**TOWN OF NEWBURGH
PLANNING BOARD
TECHNICAL REVIEW COMMENTS**

PROJECT NAME: SPARK CAR WASH
PROJECT NO.: 23-23
PROJECT LOCATION: SECTION 96, BLOCK 1, LOT 4 & 5
REVIEW DATE: 29 JANUARY 2025
MEETING DATE: 6 FEBRUARY 2025
PROJECT REPRESENTATIVE: GK+A Architects, P.C.

TOWN OF NEWBURGH FIRE PROTECTION
FLOW TO BLDG. CONNECTION DETAIL

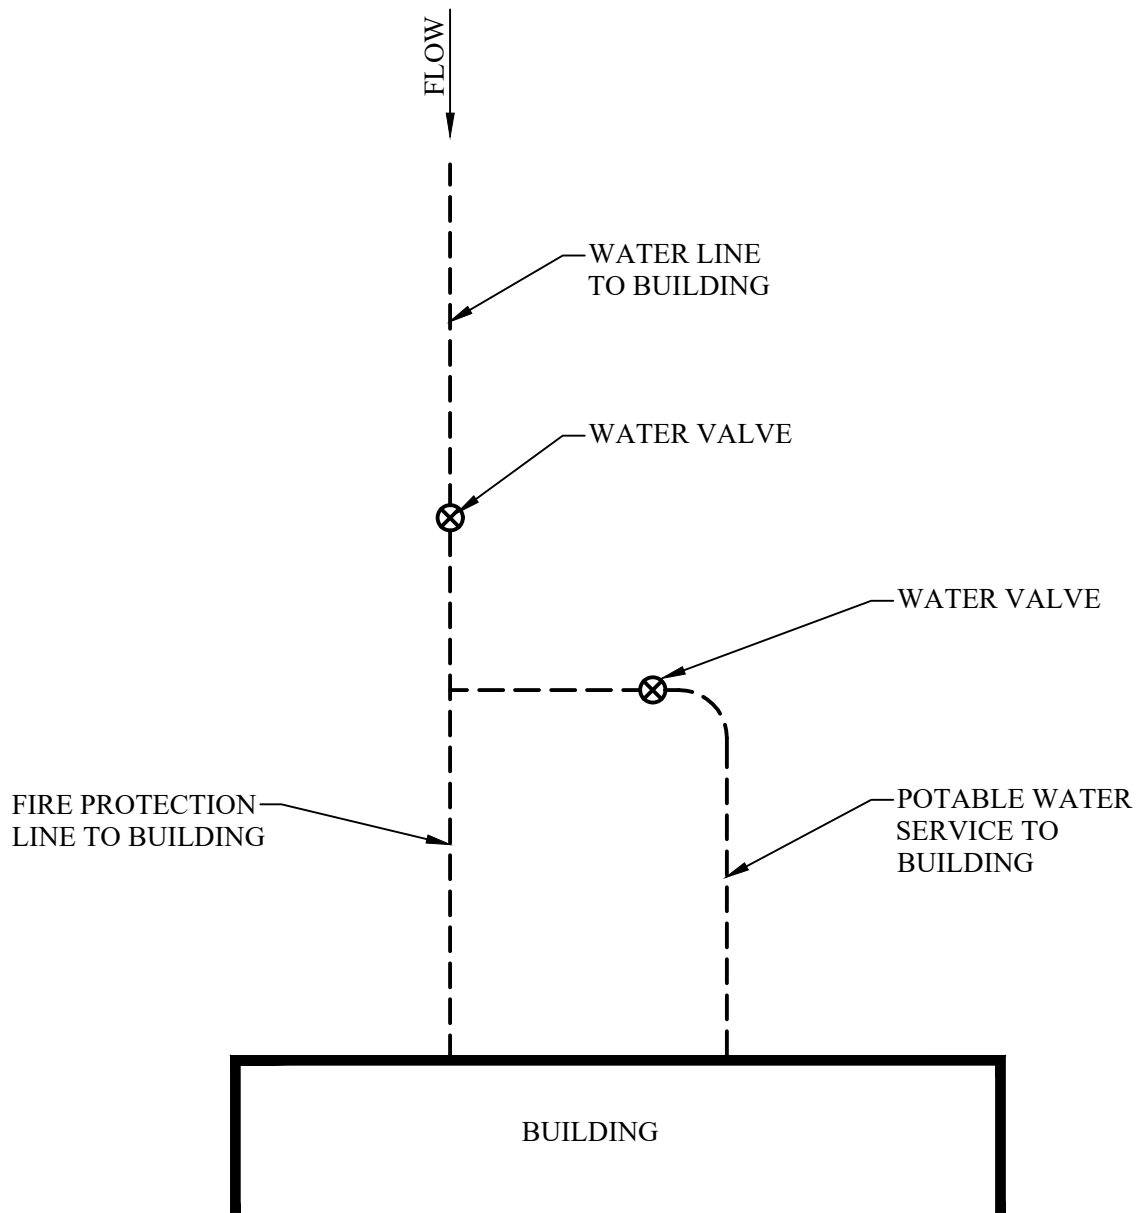
7. The structure will require a fire sprinkler system. Water system must be designed in compliance with Towns requirements. Typical detail for the Towns potable and fire suppression water line is attached.

NOTE:
 VALVING MUST BE ARRANGED SO THAT
 POTABLE WATER IS TERMINATED IF
 FIRE PROTECTION LINE IS TURNED OFF.
